SUBJECT: Forwards responds to Questions 640.01, 640.02 & 640.03 re procedure generation package.

Subject: Palo Verde Nuclear Generating Station (PVNGS)
Units 1, 2 and 3
Docket Nos. STN-50-528/529/530
File: 84-056-026; G.1.01.10

Attached for your review are APS' responses to questions transmitted by
the referenced letter. These questions, 640.01 640.02 and 640.03, are in
regard and to the PVNGS Procedure Generation Package.

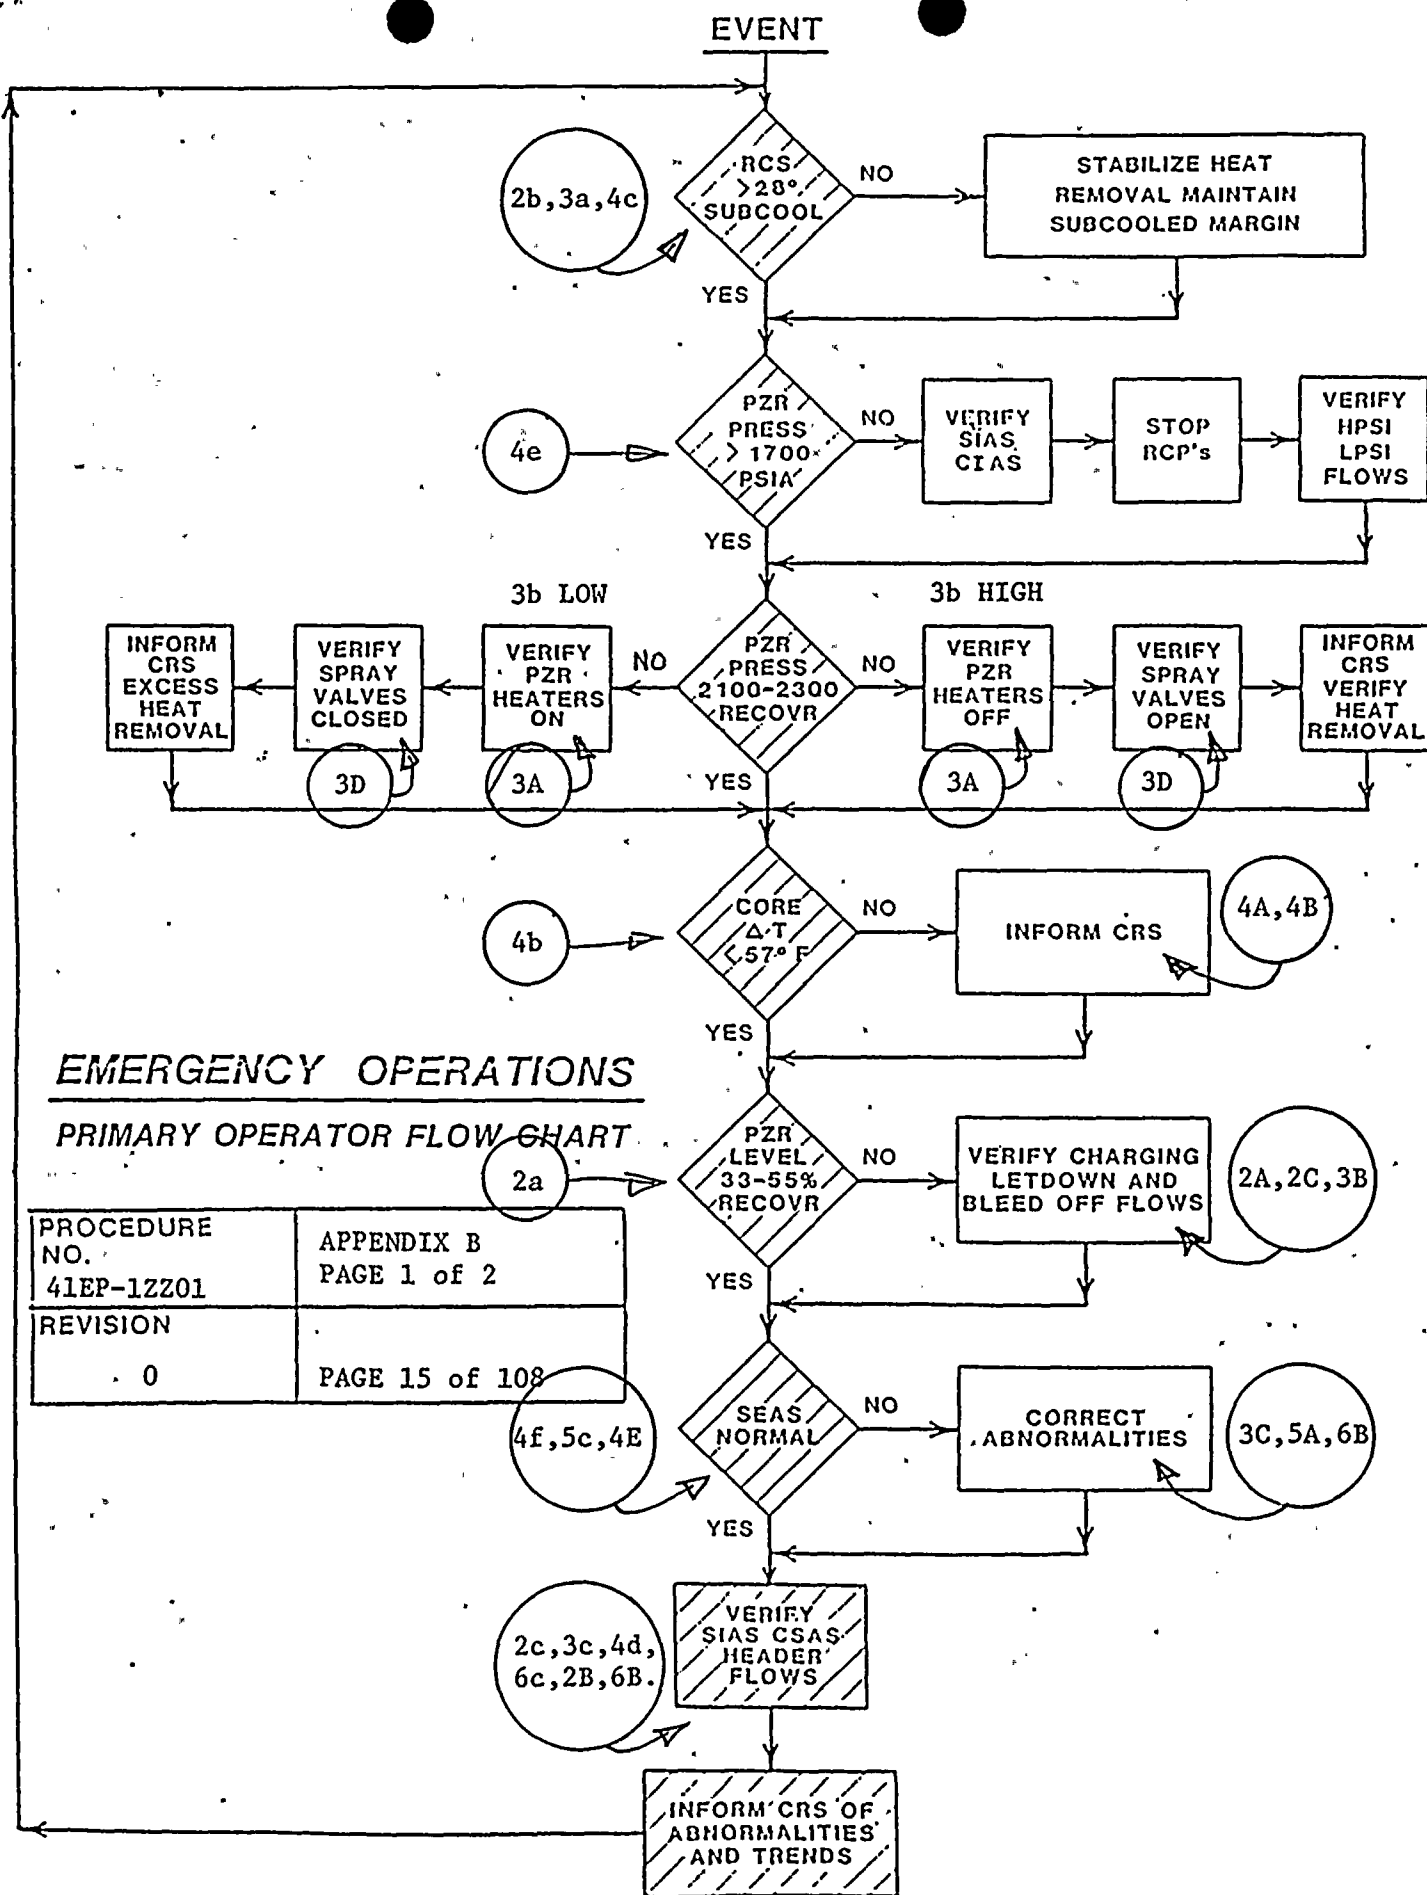
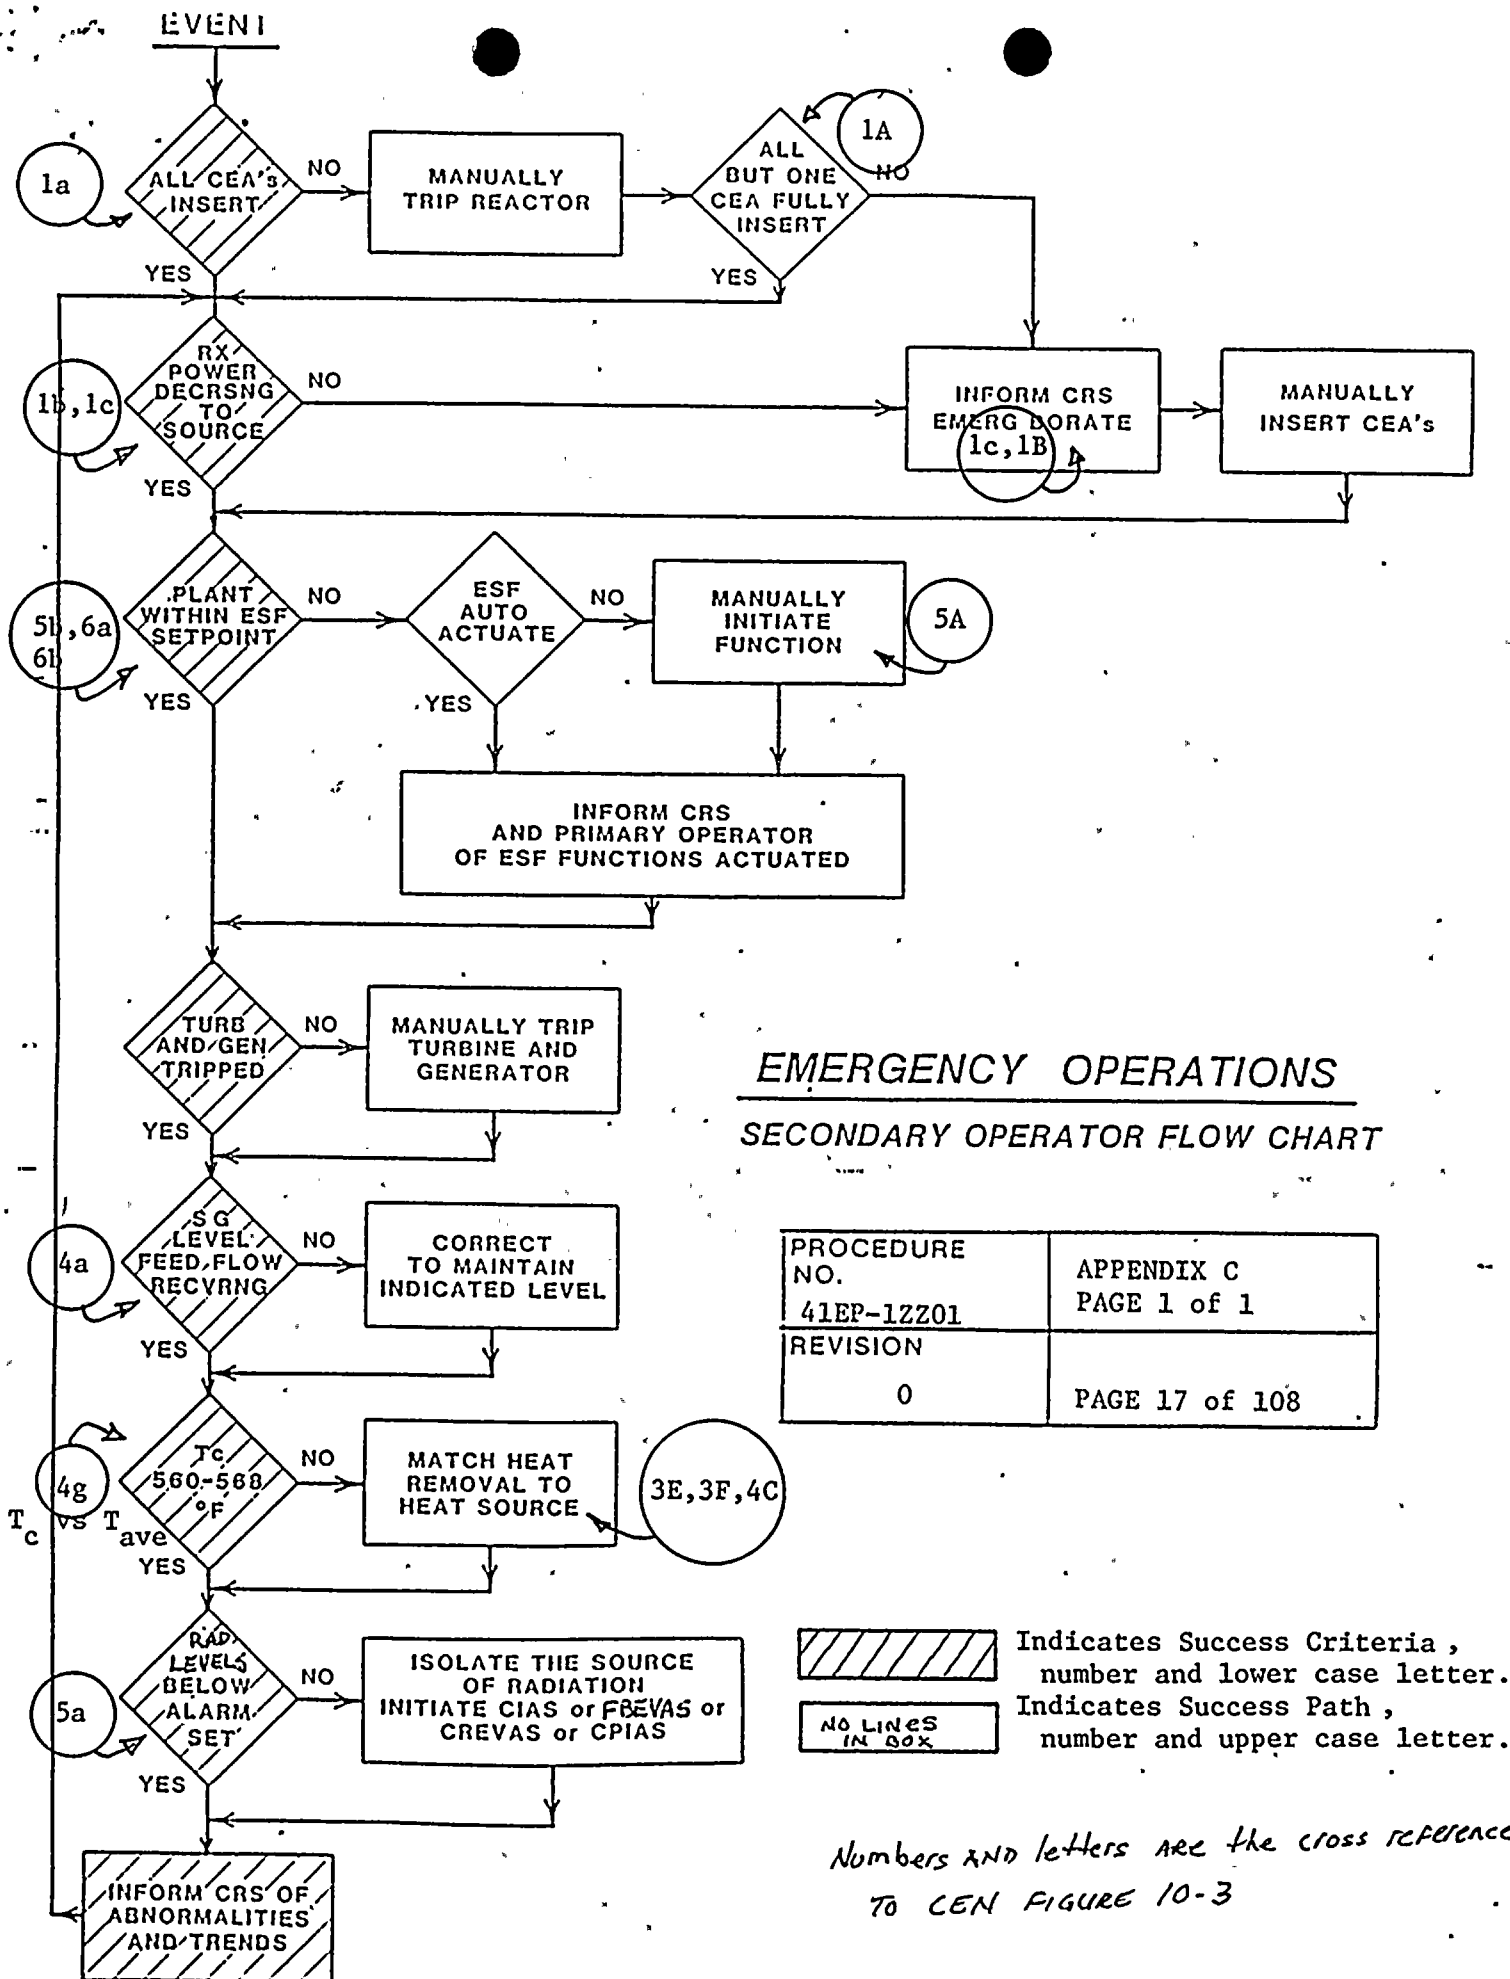
In the PVNGS Plant Specific Guideline, the safety functions as defined by PVNGS differ from CEN-152 in that RCS inventory and RCS pressure control have been combined and all safety functions dealing with containment have been combined. This change affects the safety function status check, Figure 10-3 in CEN-152, the resource assessment trees, and the specific function recovery guidelines for RCS inventory control, RCS pressure control, containment isolation, containment temperature and pressure, and containment combustible gas control. Provide sufficient information to show that the function recovery guidelines have been combined in such a manner that they reflect CEN-152 generic guidelines, or provide the technical basis, including supporting analysis, for the differences from the generic guidelines.

Upon event initiation the operators are directed to maintain safety functions. These actions are outlined in the form of primary and secondary operator flow charts Figures 1 and 2, which defines the criteria to be met to insure functions are maintained. The criteria outlined in CEN-152 Figure 10-3 is the same criteria utilized during performance of the steps of the flow charts, with the following exceptions:

- Due to plant specific design T_c is used vice T_{AVE} ; CET readings are addressed, first by maintaining subcooling, then specific readings are taken in all Recovery Procedures.
- CET readings are one of the criteria used to maintain adequate core cooling. CET readings are taken during plant statusing at various points in the Recovery Procedures.
- H_2 control is addressed in the LOCA and Functional Recovery Procedures as plant conditions warrant.

These flow charts, do not identify or name the Safety Function to be monitored, but prescribe the criteria to be verified or established, as the preferred method of stabilizing plant parameters. This method is also used as a second check of parameters and criteria by the Supervisor while performing the steps of the diagnostic flow charts. These flow charts are not dependent on how the safety functions are defined but directly address the basic criteria which will indicate the status of the safety functions. This method allows for a symptomatic approach to accident mitigation. If diagnosis is not possible the Functional Recovery Procedure will be implemented. The criteria for evaluating plan response in the Functional Recovery Procedure is identical to the criteria listed in CEN-152, Figure 10-3. When any of these criteria cannot be met the appropriate actions will be directed. This method does define which safety function is to be monitored. However, where the safety functions, as defined by CE, have been combined the criteria for verifying those safety functions have also been combined. Operator actions are then directed based on this criteria.
